EASTERN CORRIDOR SEGMENTS II AND III (PID 86461)  
**COMBINED LINWOOD/EASTERN INTERCHANGE AND US 50/RED BANK INTERCHANGE FOCUS AREA**  
**ADVISORY COMMITTEE MEETING #2**  
R.G. CRIBBET RECREATION CENTER • MAY 22, 2018

## MEETING #2 NOTES

**Figure X-3A-1**

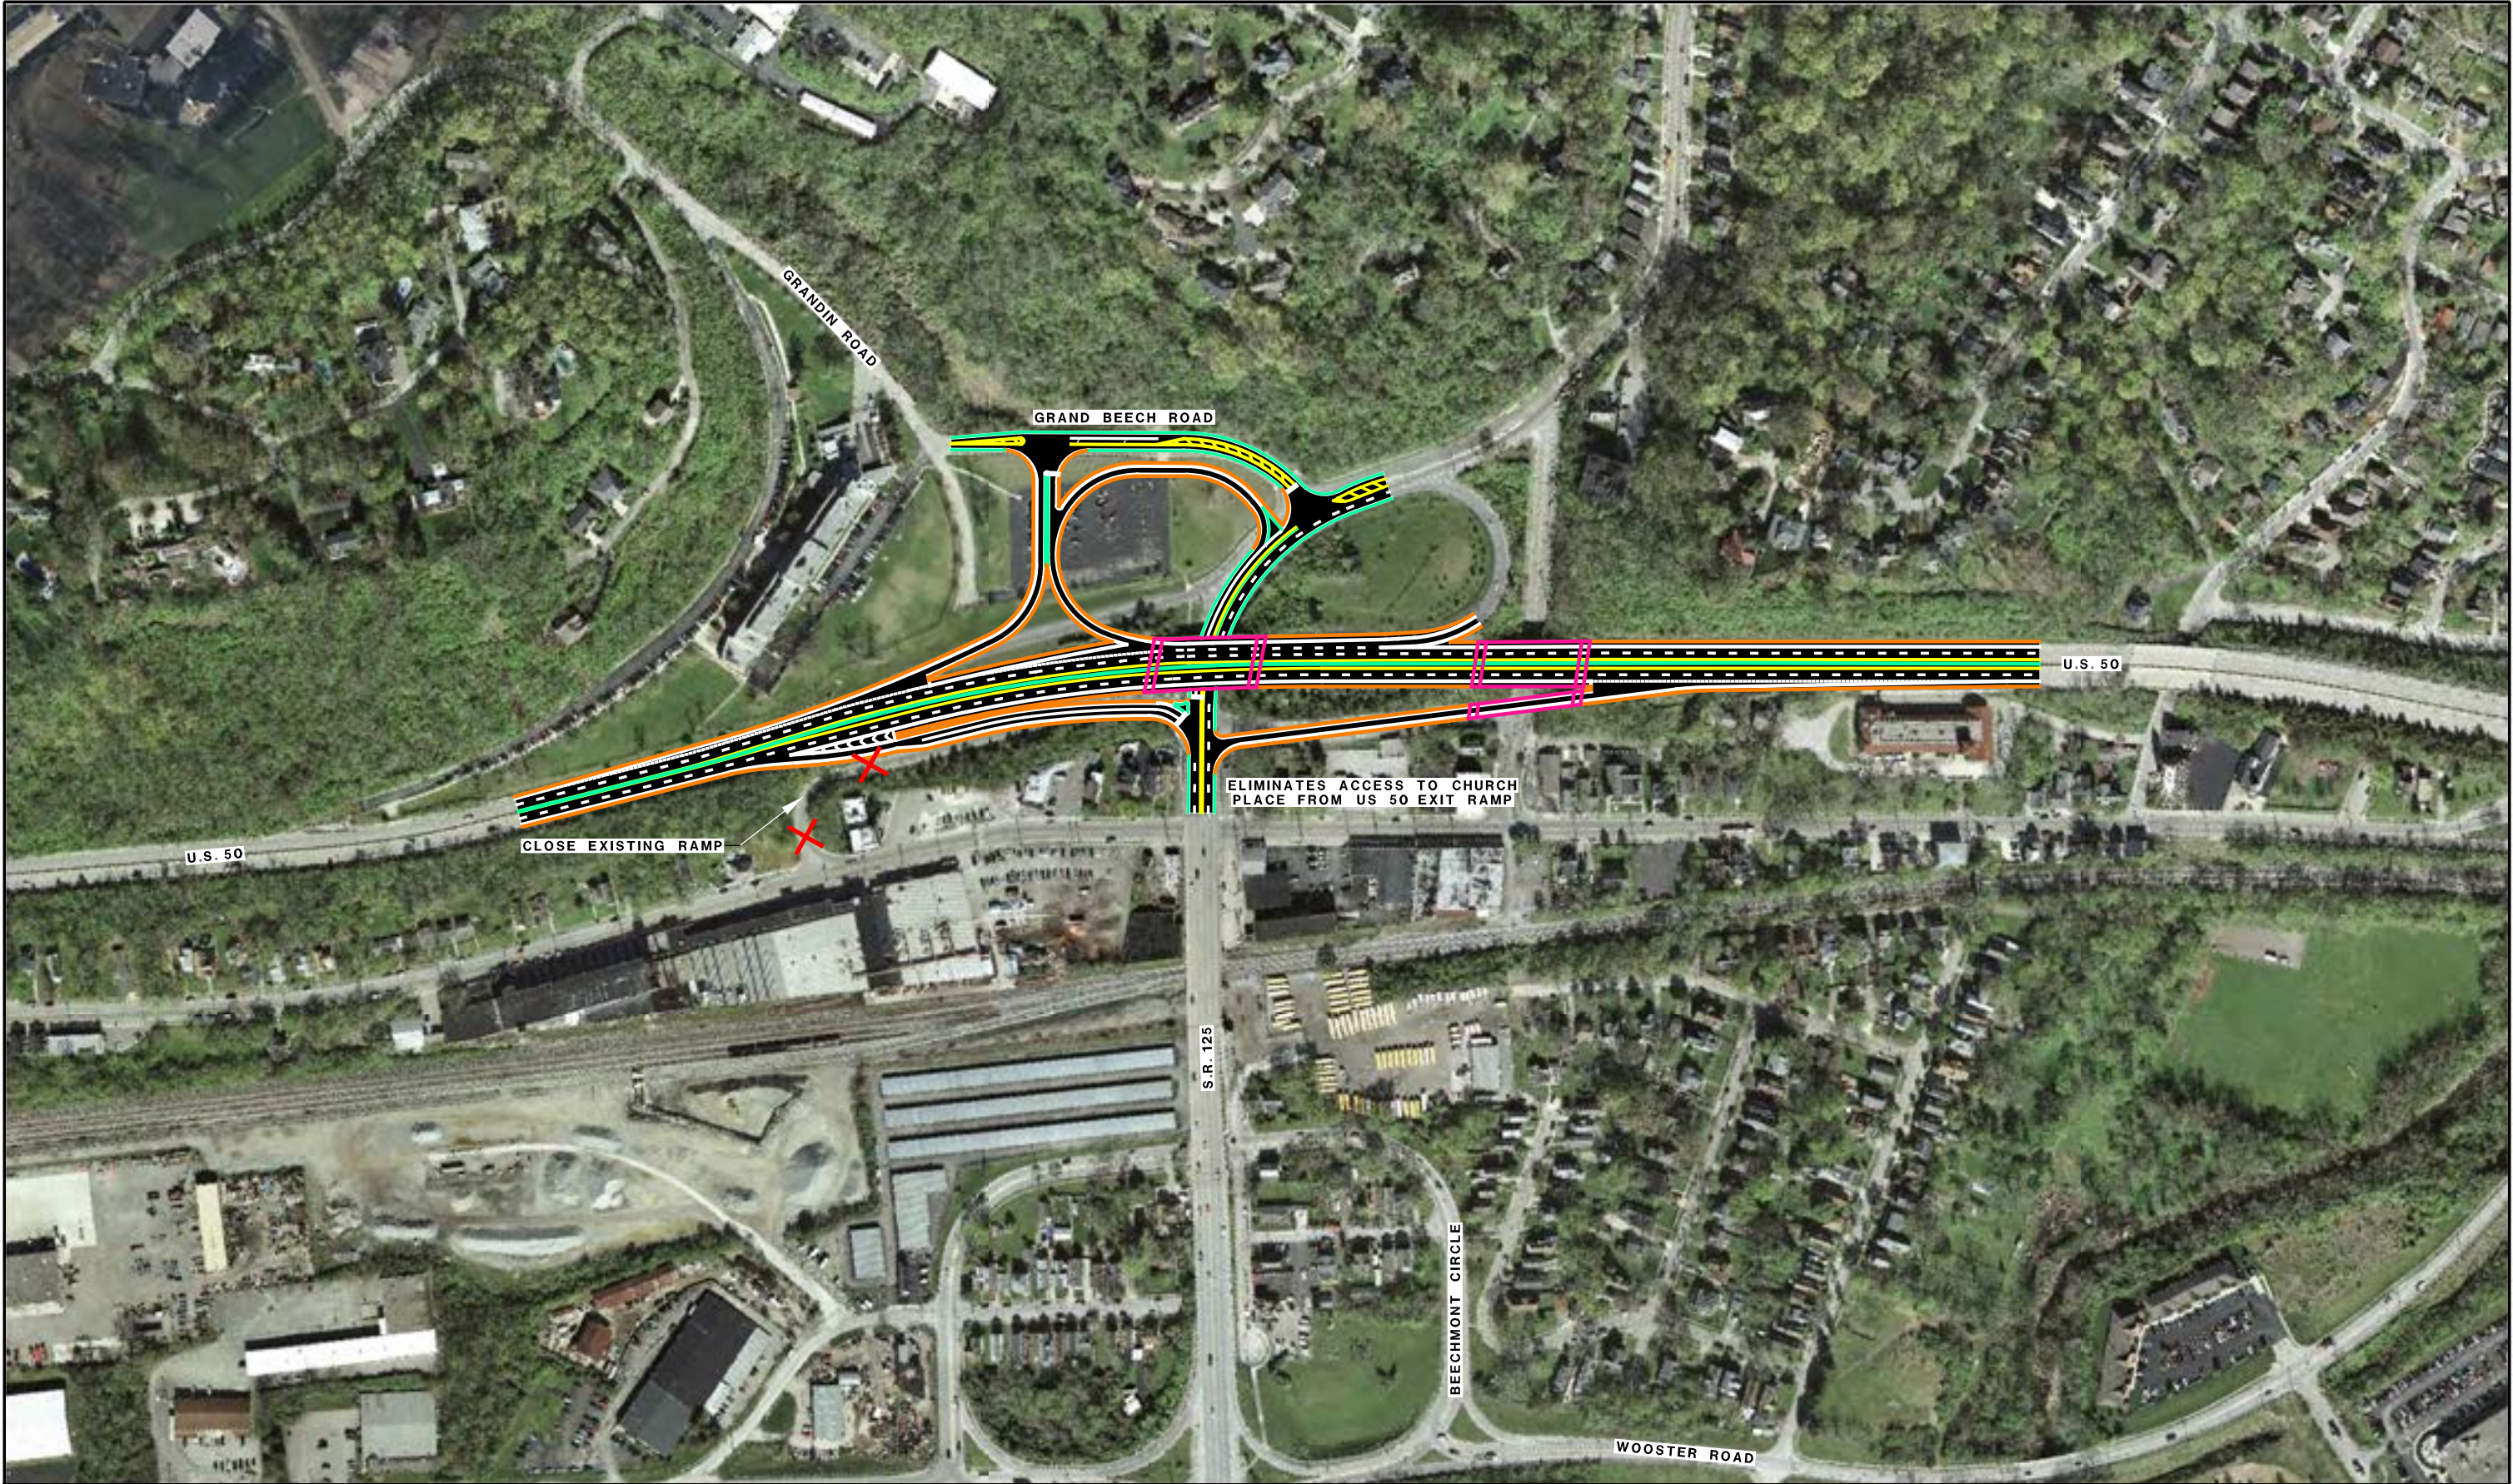
- Columbia Parkway is under-utilized between SR 125 and Red Bank Road.
- Modeling of the concept shows that it would shift 5,000 vehicles a day (approx. 1/3 of traffic) off Wooster. Approximately 700 vehicles would shift off Linwood (approx. 1,400 cars use this exit during evening peak-hours).
- Initial modeling of the concept shows that it does not work very well.
  - Although the Level of Service (LOS) would be “B” (some delays) during morning peak-hours, the LOS would be “F” (unacceptable) during evening peak-hours.
  - It would require drivers entering US 50 to weave in among those exiting, which creates a safety concern.

- General comment/question - At the initial meeting for the Linwood/Eastern/Red Bank focus area, there was discussion regarding potentially allowing truck traffic on Columbia Parkway. Is this still a consideration? If so, Mariemont will have additional comments for this combined focus area.

- There is no recommended change. Trucks are permitted on US-50 between the ramps to Eastern Avenue and Red Bank Road.

**Figure X-3A-2**  
**ADDITIONAL RAMPS AT**  
**S.R. 125 AND U.S. 50 INTERCHANGE**

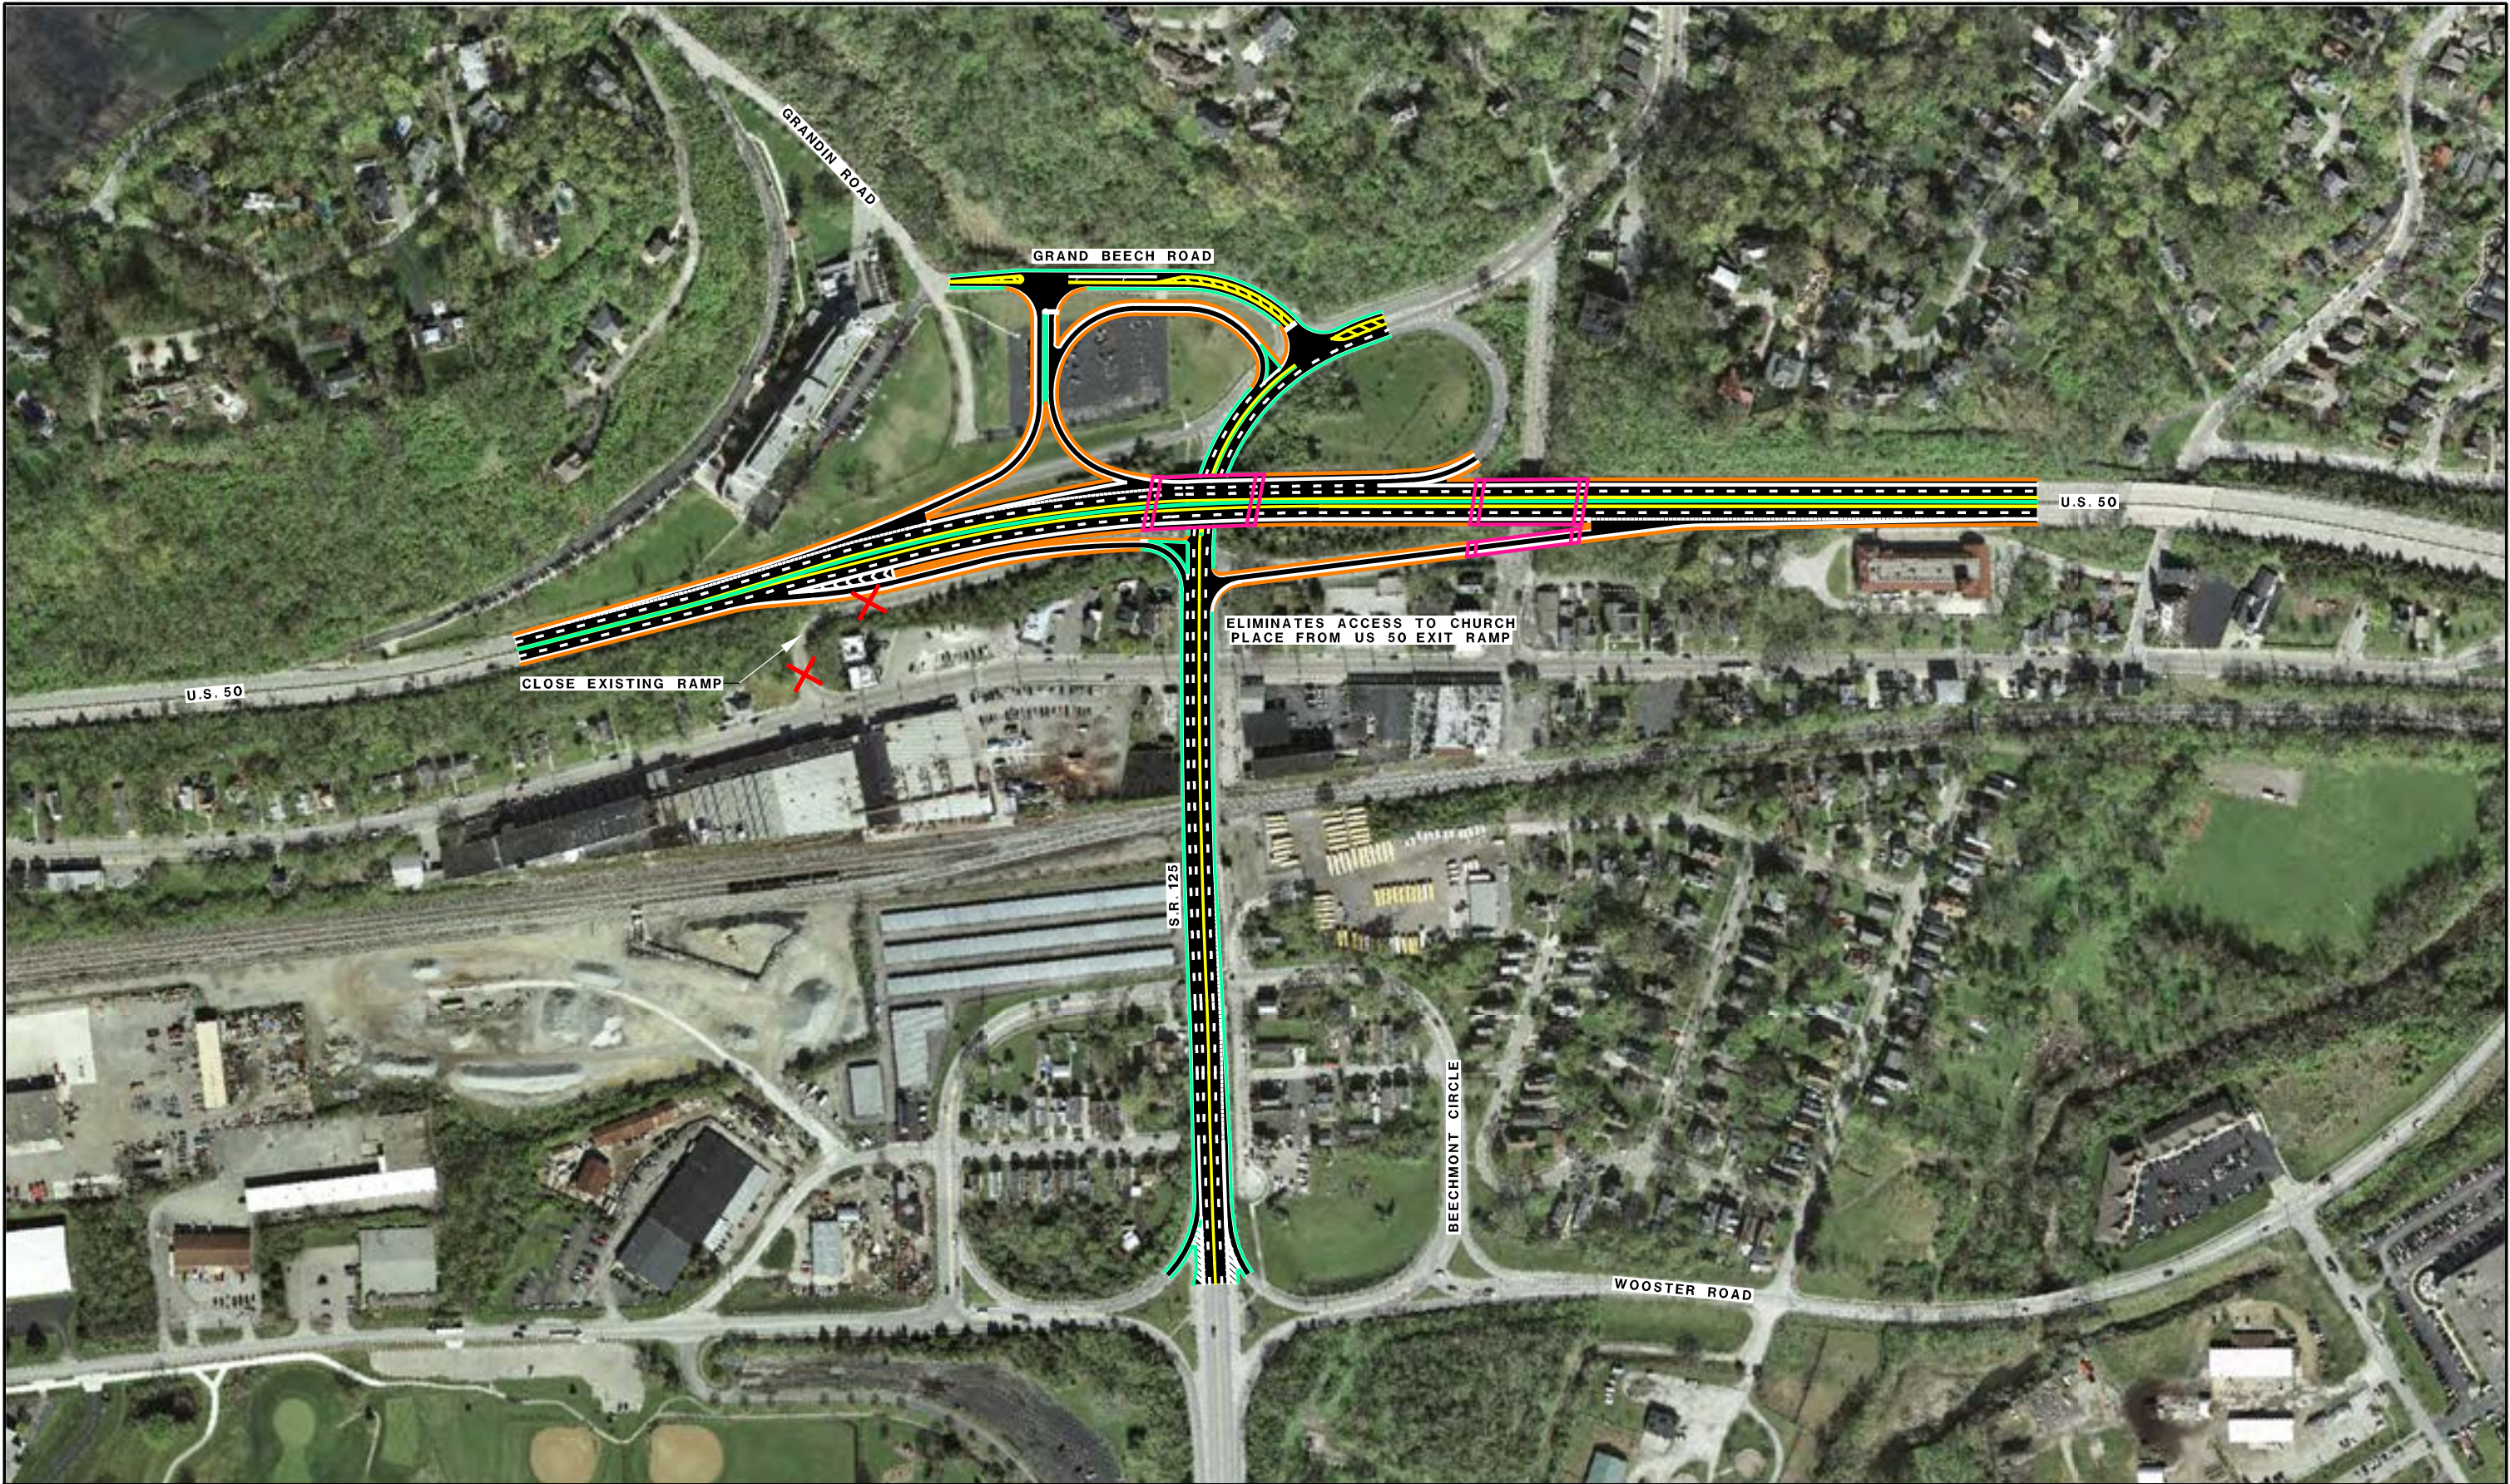
- This concept would cost more than concept X-3a-1 to construct, but it works better to improve safety and traffic operations.
- This concept increases connections to major arterial roads but loses local access.
- If the SR 125 bridge is widened as part of this concept, consider adding a bike path and addressing pedestrian needs.
- When considering bike path connections, keep in mind that some connection to Mt. Lookout is needed.
